MIL-R-6106/19E
AMENDMENT 1
20 February 1998

MILITARY SPECIFICATION SHEET

RELAYS, ELECTROMAGNETIC, PERMANENT MAGNET DRIVE,
25 AMPERES, SPDT, HERMETICALLY SEALED

This amendment forms a part of MIL-R-6106/19E, dated 24 October 1990, and is approved for use by all Departments and Agencies of the Department of Defense.

SOCKET PIN TERMINAL

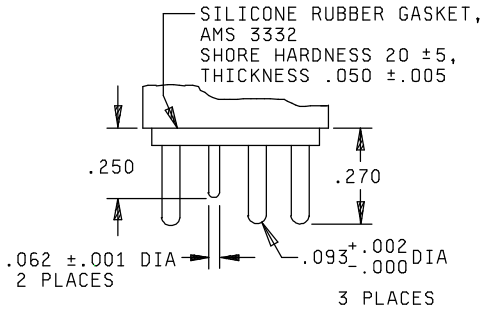
* FIGURE 1, socket pin terminal: delete and substitute the following to correctly show the pin dimensions from the header rather than the gasket.
